**ZANCOR
HOMES**

PURCHASER REQUEST FOR EXTRAS
Purchaser: M. Tammami & M. Tammami
Res. No: 289-234-017 Bus. No: 647-294-5699

Subdivision: King's Bridge

Lot No.	House Type	Elevation	Date Required	Date Ordered
<u>26</u>	<u>Medium</u>	<u>14.</u>

Partial Second Floor Elev. 'B'

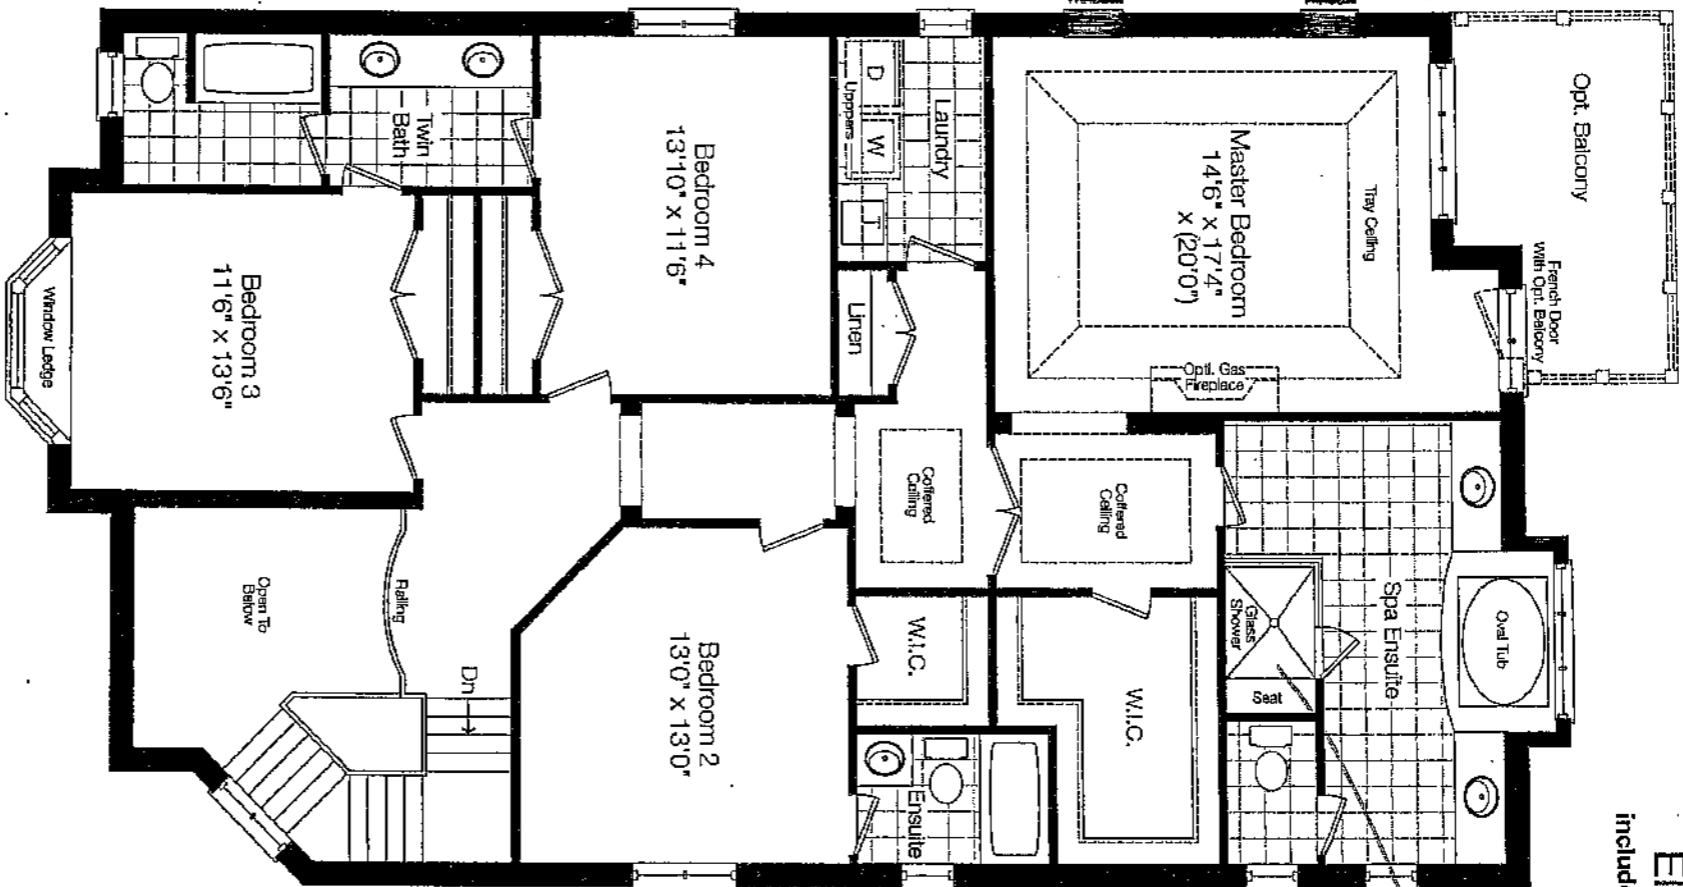
"OFFICE USE ONLY"	ITEM	DESCRIPTION	PRICE
	④	Upgrade Brick	
		Upgrade #13	
	⑤	Windows Only	
	⑥	Inclusion of standard glass sliders in garage 10 mm	
		Frameless glass sliders.	
	⑦	Additional windows to living room to be built in between existing windows	
	⑧	delete 12 transoms windows in master bedroom (for allowable window coverage)	
SUB-TOTAL			
HST			
TOTAL AMOUNT ▶

⑦ M.H.
N.I.
WINDOW
SAME AS
ON
BOTH SIDES

Second Floor Elev. 'A'

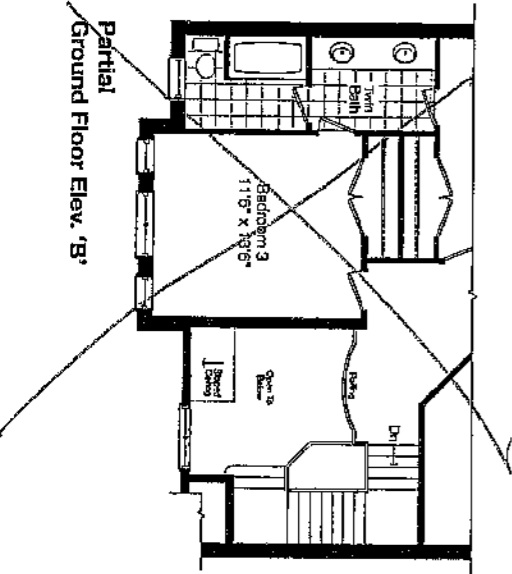
ITEM	DESCRIPTION	PRICE
	CLARIFICATION	
9	Re: Windows	
	To accommodate other windows we having been delete windows in master units as shown.	
	* Also #8 on PES dated Feb 28/12 Still delete those windows	
	SUB-TOTAL	
	HST	
	TOTAL AMOUNT ▶

⑧
DELETE 2
TRANSOM
W/ WINDOWS

⑩
FRAMELESS
GLASS
SHOWER
N.I.
